Shanta Industries Ltd.

17th March 2015

Observations Building 1

Plan of building 1 showing missing bracing

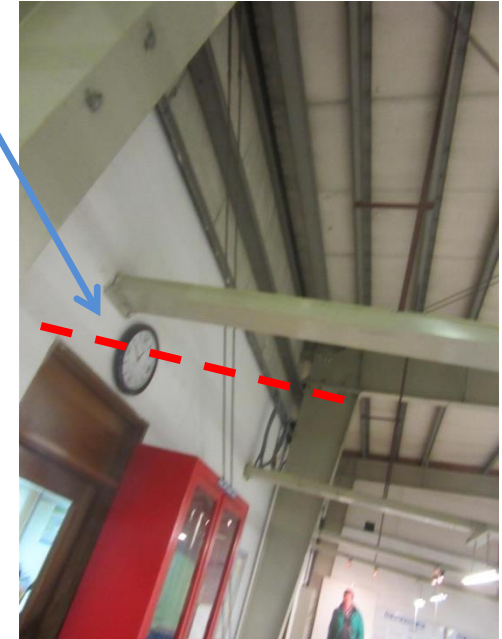
Vertical tie bracing missing

- Most of bracing shown on the North side of the building is not present in locations indicated on the drawings.
- Evidence that bracing has been removed.
- Building stability to be assessed by building engineer and bracing reinstalled so that it matches design drawing and calculations.

Ground-bearing slab with high stacking loading

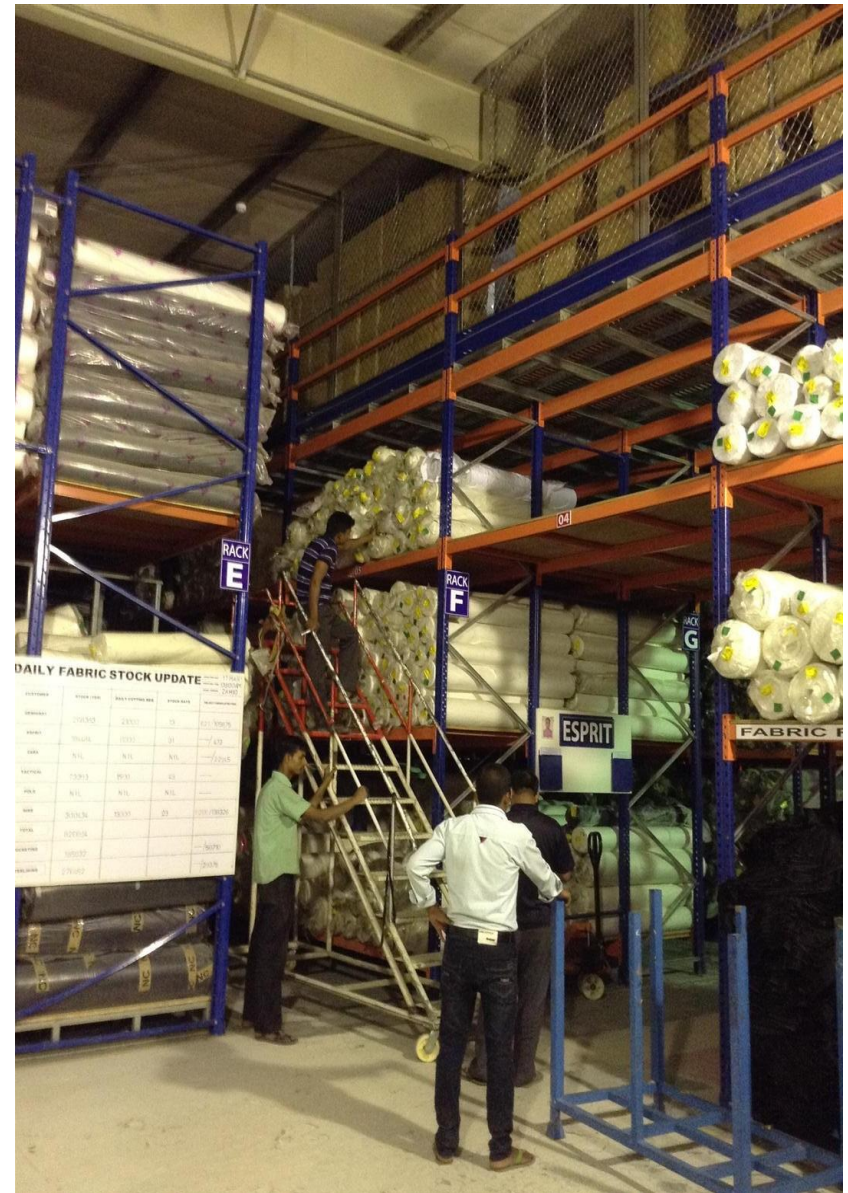
- High stacking loading on ground bearing slab in highlighted area.
- Building Engineer to assess if slab has capacity for the additional loading taking into account slab thickness, reinforcement and allowable bearing pressure.

Corrosion damage to base of columns

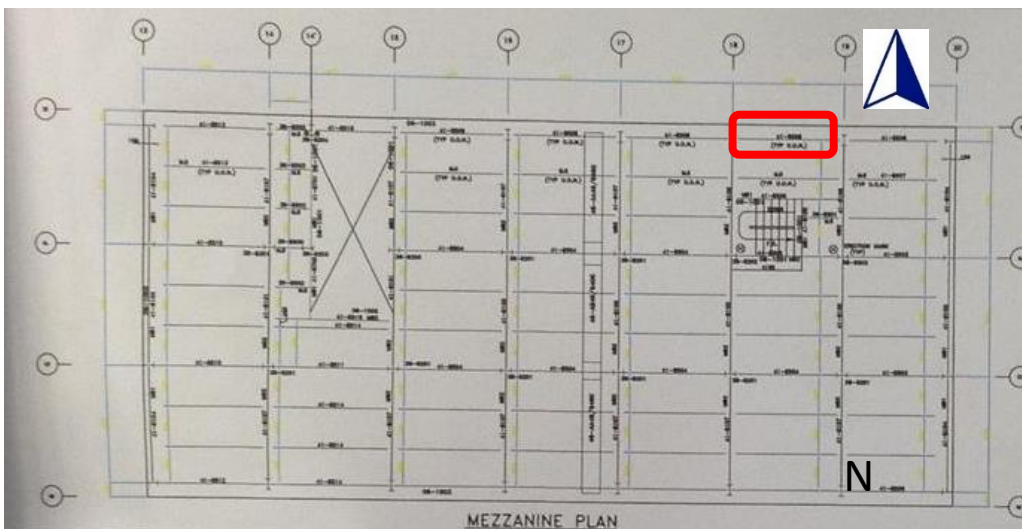
- Evidence of corrosion damage near the base of a number of columns on the ground floor
- Building Engineer to assess extent of corrosion, and specify preparatory work and protective coating to prevent further damage.

Location of missing vertical bracing.

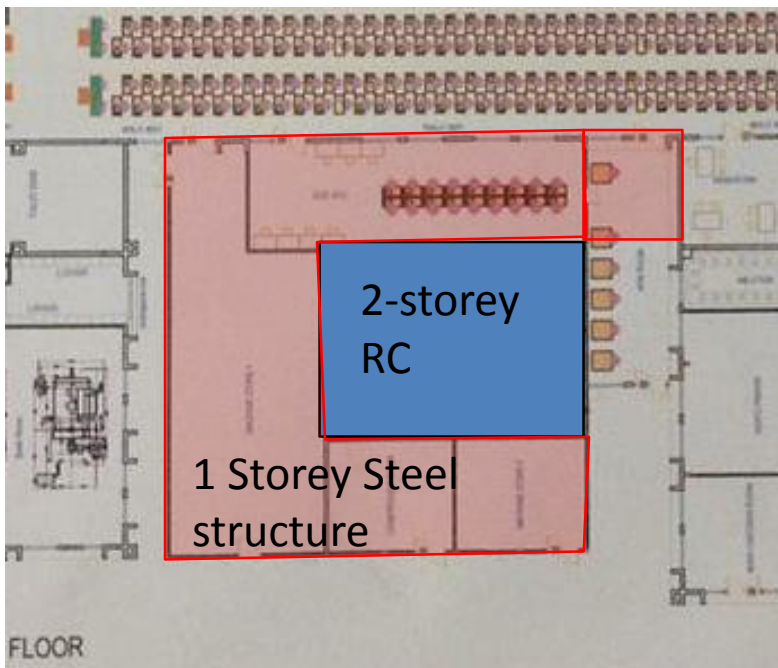
- Vertical tie bracing missing on the ground floor in location shown.
- Evidence that bracing has been removed.
- Building stability to be assessed by Building Engineer, and bracing reinstalled to match design drawing and calculations.

Non-engineered roof structures

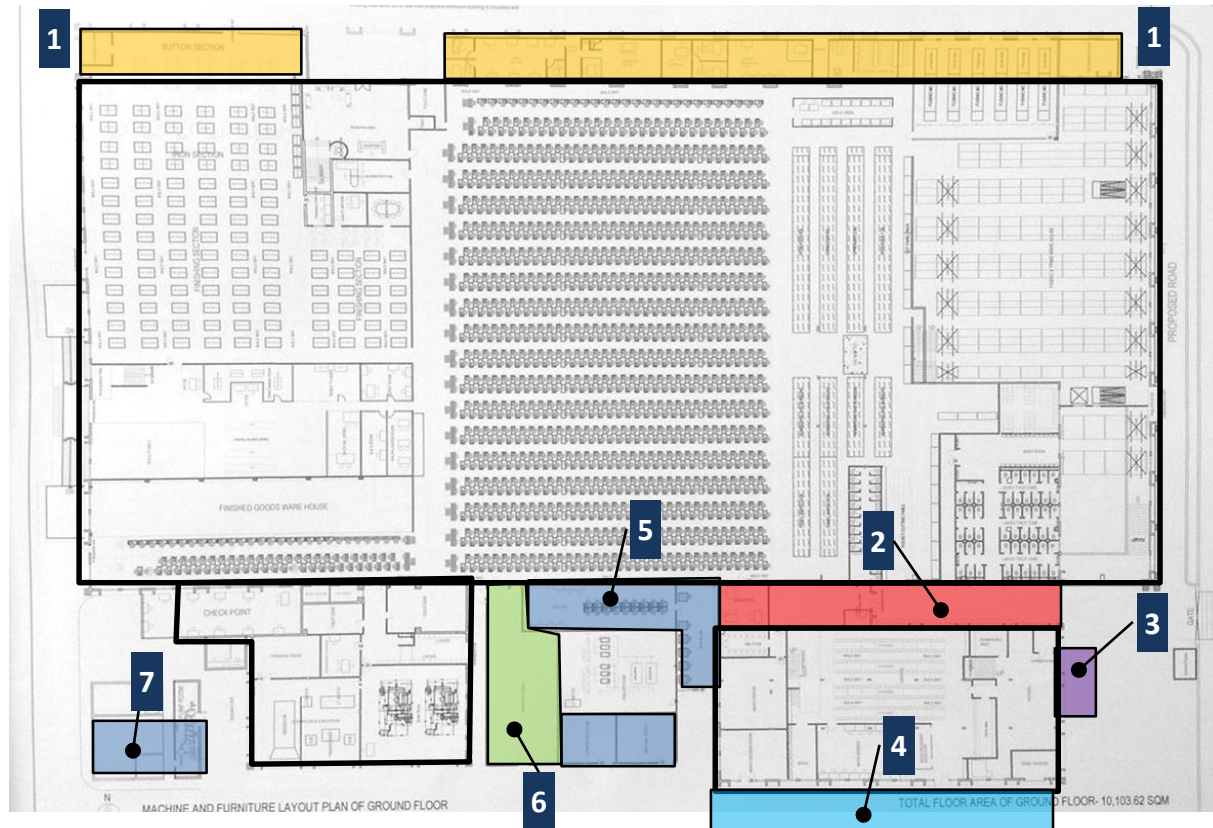
- Undocumented and apparently non-engineered roof structures in locations shown.
- Lightweight roof structures subject to uplift in high winds
- Building Engineer to assess structures and outline strengthening measures as necessary.
- Refer to next sheets for examples.

Non-engineered Roof Structures

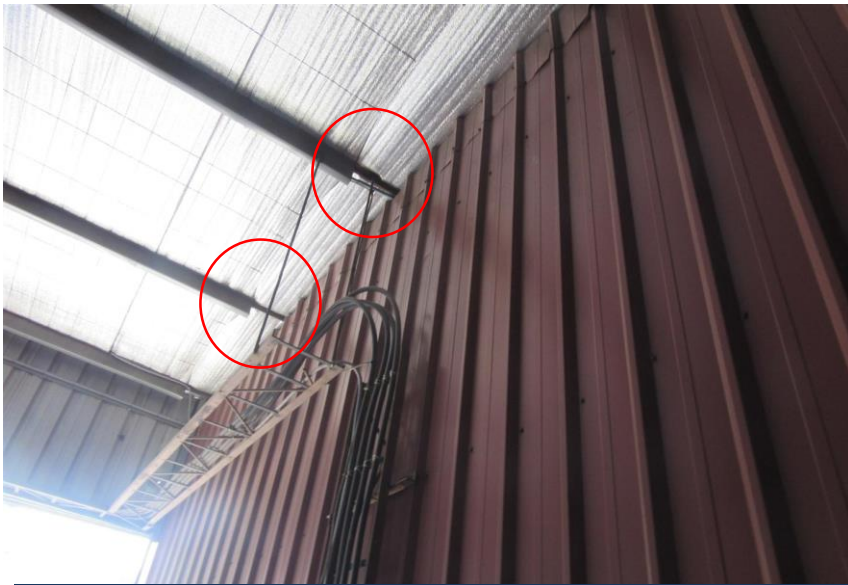
1. – Northern Extension of Building 1

2. – Infill roof between Buildings 1 & 2
